ARCHITECTURAL REVIEW BOARD
AMENDED REPORT

PROPOSAL: To construct a one-story religious classroom and office

LOCATION: Northeast corner of 4th and "V" Streets

APPLC. NO. 80-52 MEETING DATE June 4, 1980 CPC ITEM NO. 5

EXTERIOR ELEVATIONS

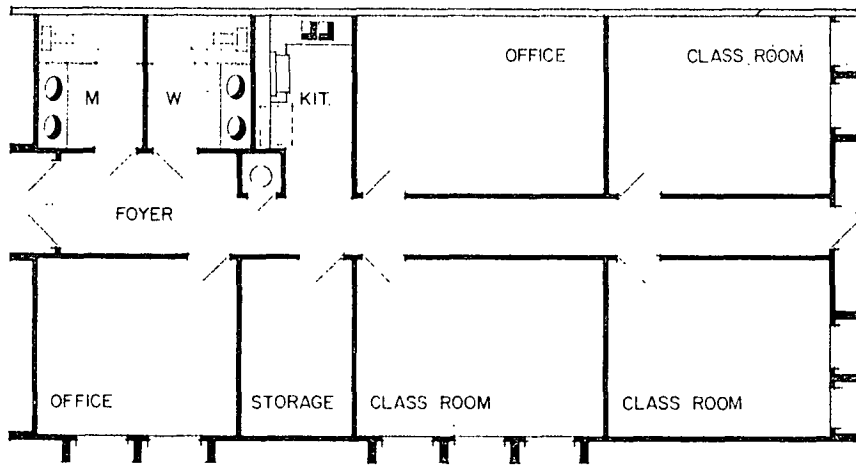
1. North elevation: This elevation is a flat, stucco wall without windows or any relief. This needs further study.
2. The tile material on the cap of the structure is not in character with the overall design.
3. A pitched roof would be more compatible with surrounding properties.
4. The trash area is not indicated on the site plan.

5. The roof top equipment is not indicated on the plans.
6. The rear door on the east side does not relate to the design of the building.
7. The basic box form design, with wing-wall elements, is out of character and does not relate to surrounding structures.

The staff therefore concludes that the basic building form needs to be re-designed in order to comply with the Design Review Guidelines. The staff suggests the Board provide additional direction to the applicant in order to redesign the structure.

1. The tile shall be replaced with brick.
